**SUBJECT: DEMONSTRATION / DELIVERY HOLD – Compliance Recall 15C09 –
 Supplement #4**
 Certain 2011-2013 and 2015 Model Year F-650 / F-750 Vehicles with 70% Fixed Seat
 Front Passenger Fixed Seat Restraint Anchorage Point

CERTAIN 2011-2013 AND 2015 MODEL YEAR F-650 AND F-750 VEHICLES WITH 70% FIXED SEAT — FRONT PASSENGER FIXED SEAT RESTRAINT ANCHORAGE POINT

FIGURE 1

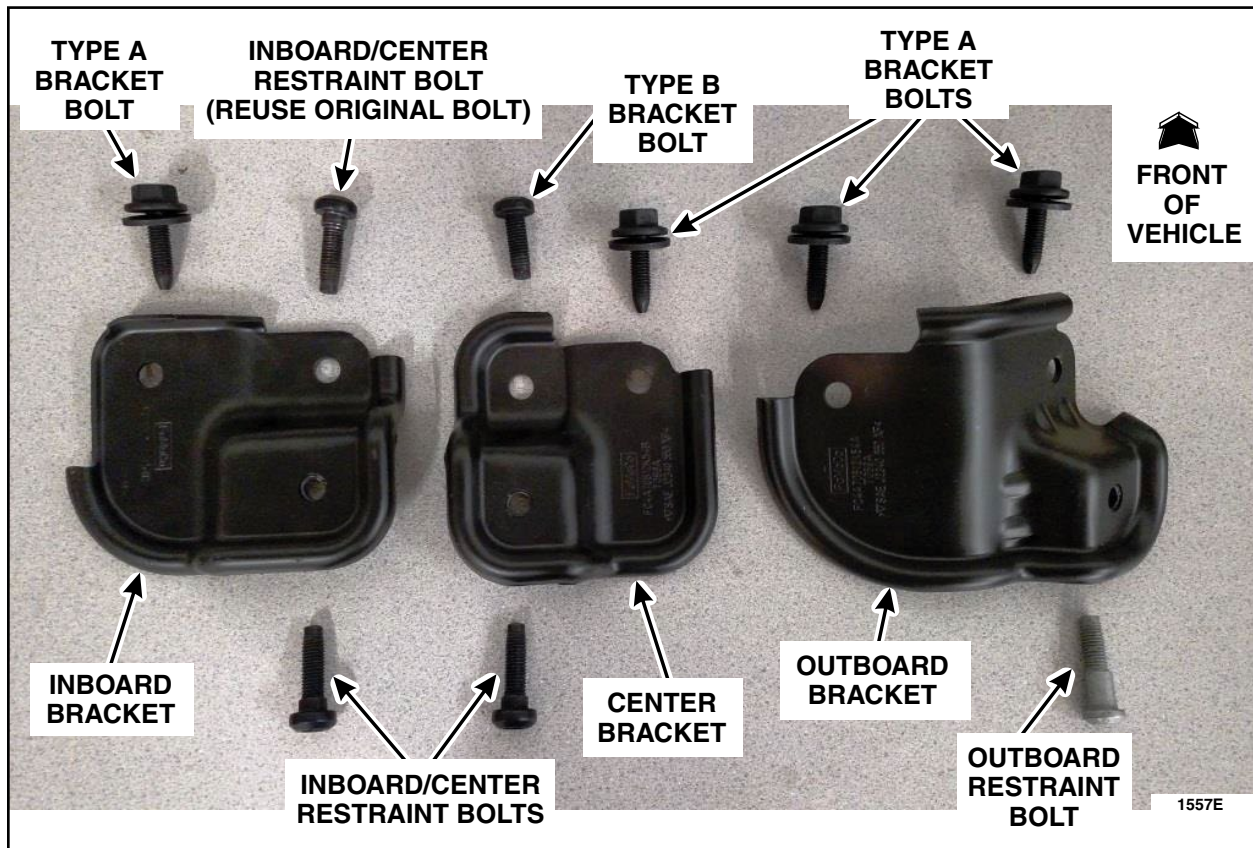
NOTE: For identification of the bolt and bracket locations included in the kit see Figure 1.

FIGURE 3

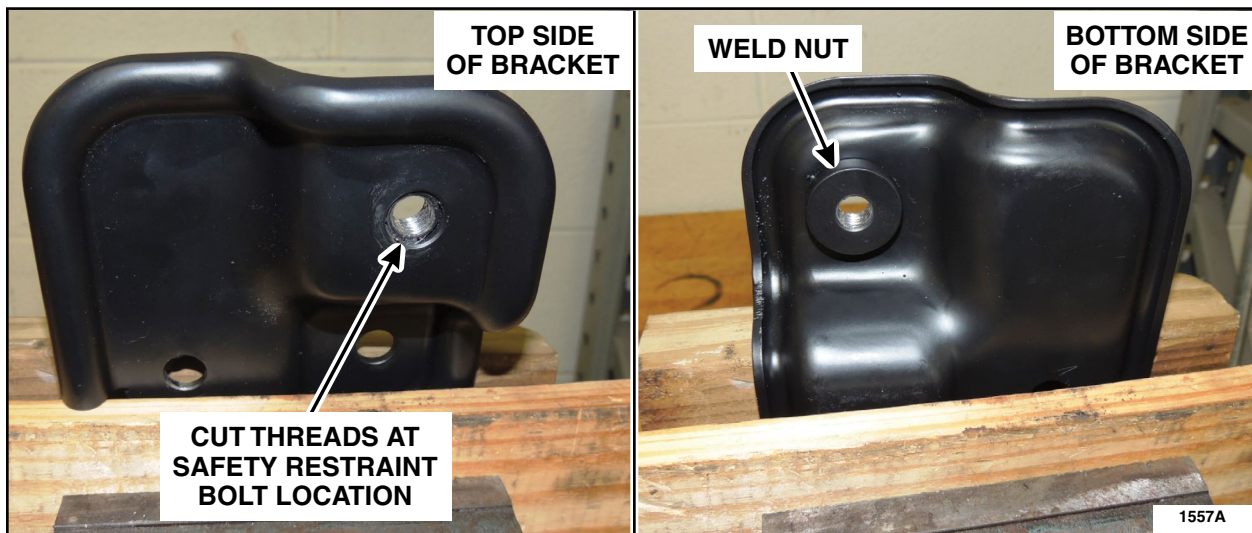
2. Use the *new* restraint bolts and an impact wrench to cut threads into the weld nut from the top side of each bracket. Use a bench vice to carefully secure the brackets during the thread cutting process. See Figure 3.

NOTICE: DO NOT allow the shoulder of the bolt to contact the bracket during this step.

NOTICE: DO NOT use a tap to cut the threads.

FIGURE 4

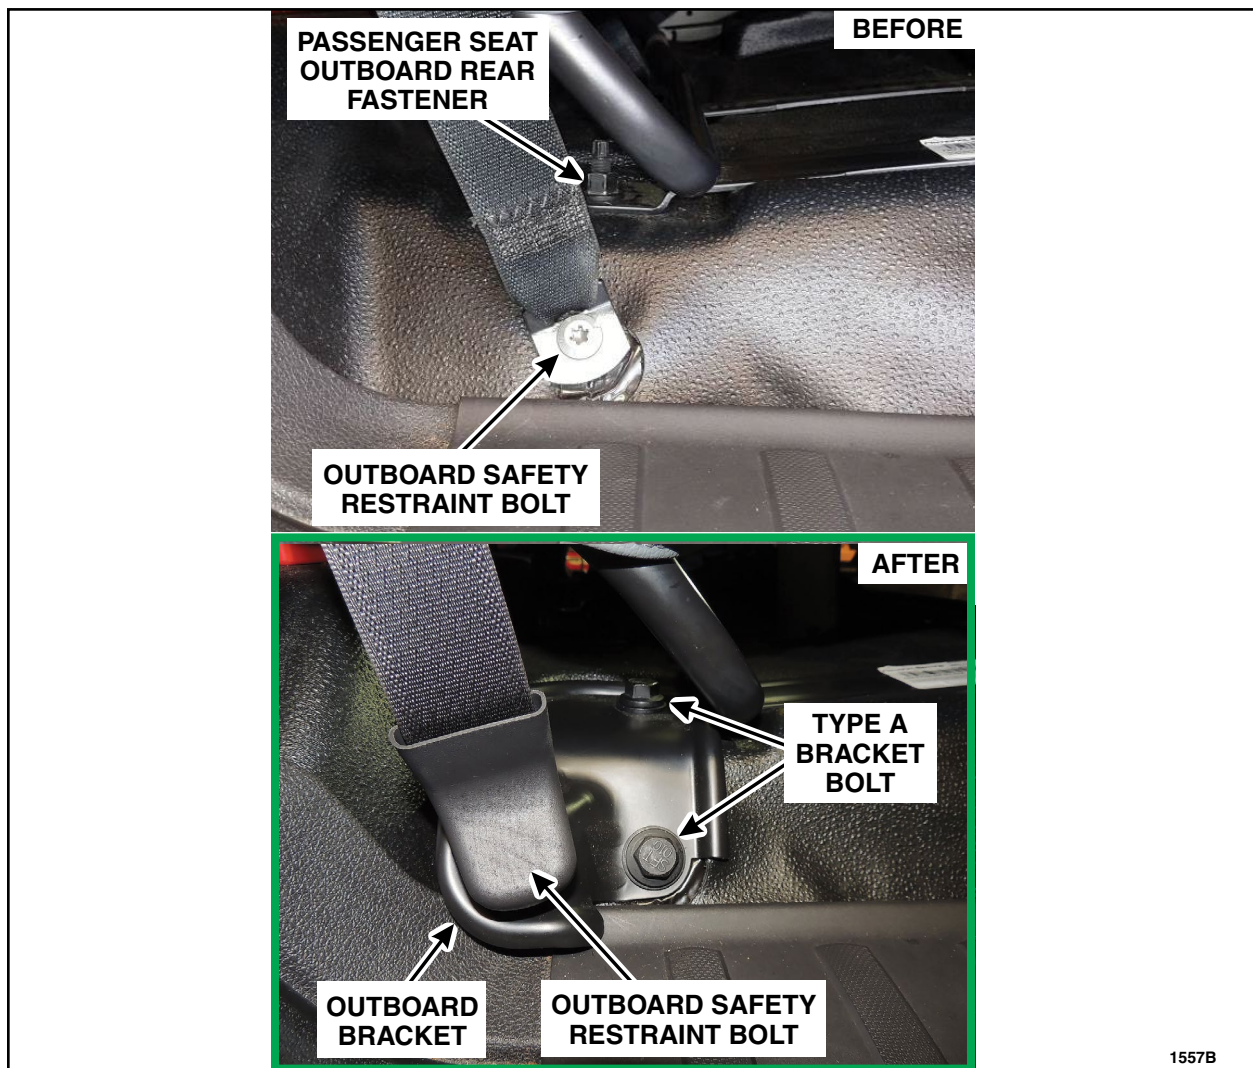
3. For all regular cab and crew cab vehicles, install the outboard bracket (See Figure 4). For all super cab vehicles, proceed to Step 4; the outboard bracket will not be used.

a. Remove and discard the outboard safety restraint bolt and the passenger seat outboard rear fastener.

b. Install the outboard bracket as shown with *new* bolts.

- Install a type A bracket bolt in the original restraint location and tighten to 30 lb.ft (40 Nm).
- Install a type A bracket bolt in place of the original seat fastener and tighten to 41 lb.ft (55 Nm).

c. Install the safety restraint and *new* outboard restraint bolt to the relocation bracket and tighten to 30 lb.ft (40 Nm).

FIGURE 5

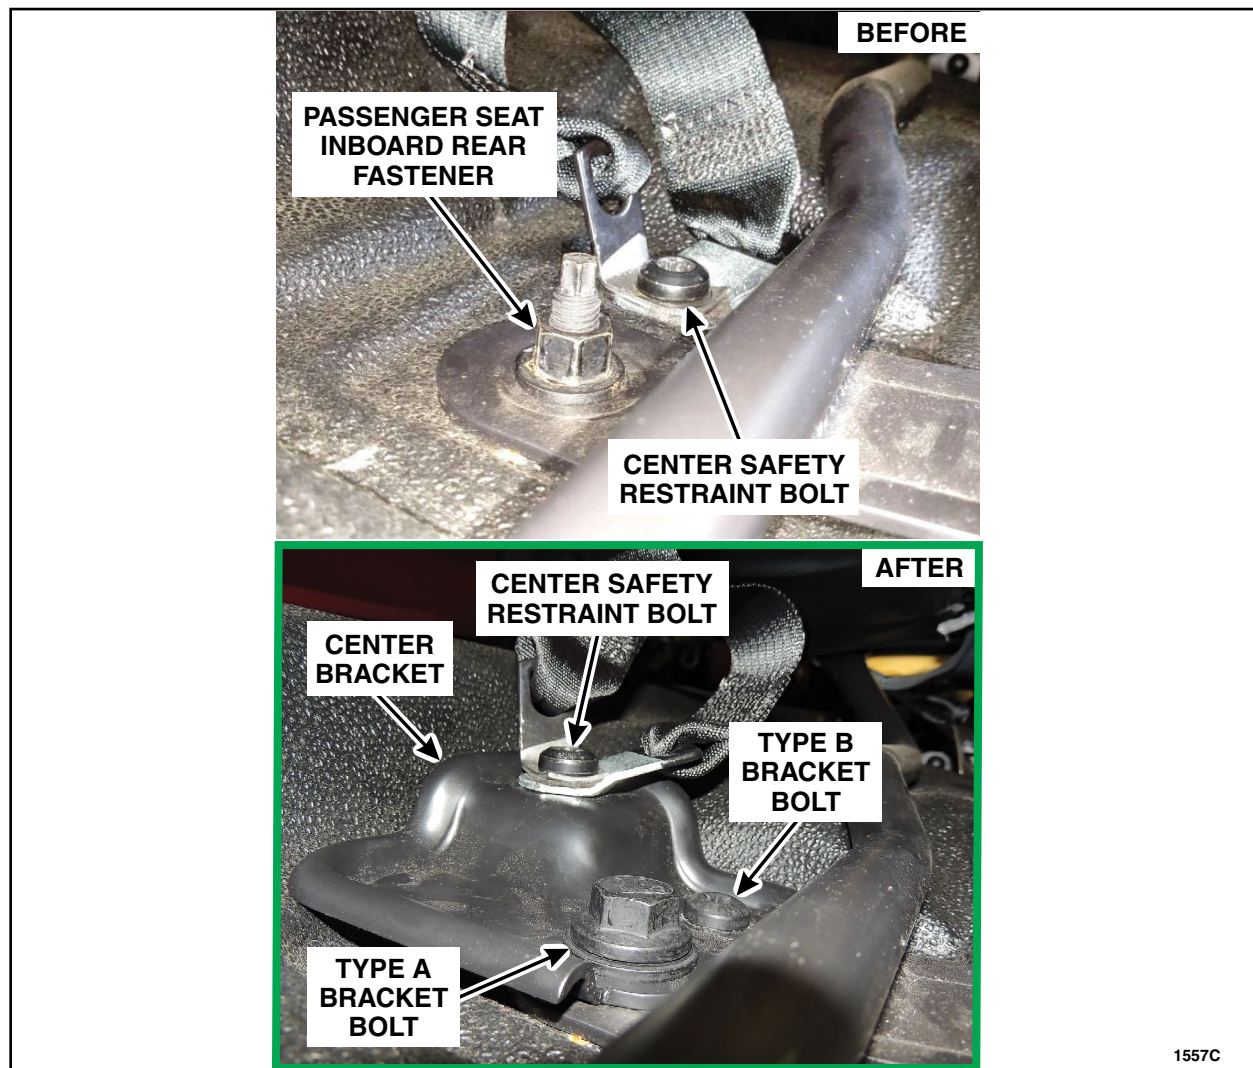
4. Install the center bracket (See Figure 5):

- a. Remove and discard the center safety restraint bolt and the passenger seat inboard rear fastener.

- b. Install the center bracket as shown with a *new* type B bracket bolt in the original restraint location, and a *new* type A bracket bolt in place of the original seat fastener. Tighten both bolts to 41 lb.ft (55 Nm).

- c. Install both safety restraints and *new* inboard/center restraint bolt to the relocation bracket and tighten to 41 lb.ft (55 Nm).

FIGURE 6

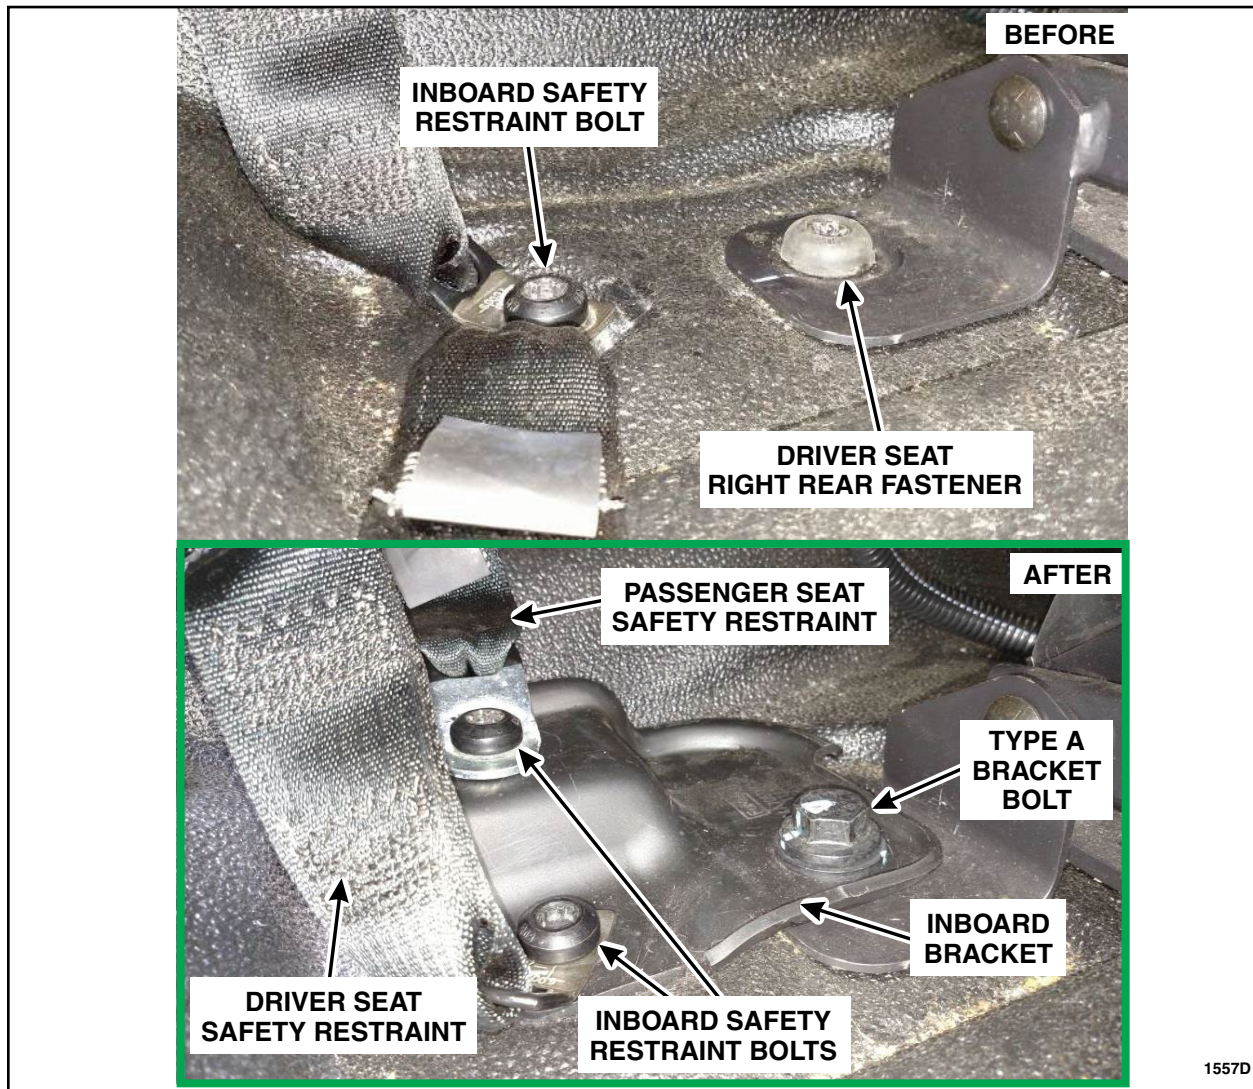
5. Install the inboard bracket (See Figure 6):

- a. Remove and discard the driver seat right rear fastener.

- b. Remove the inboard safety restraint bolt. This bolt will be reused for inboard bracket installation.

- c. Install the inboard bracket with a new type A bracket bolt in place of the original seat fastener and tighten to 41 lb.ft (55 Nm).

- d. Reusing the inboard safety restraint bolt, install the driver seat safety restraint **IN THE ORIGINAL LOCATION** and tighten to 30 lb.ft (40 Nm).

- e. Install the passenger seat safety restraint and new restraint bolt to the relocation bracket and tighten to 30 lb.ft (40 Nm).
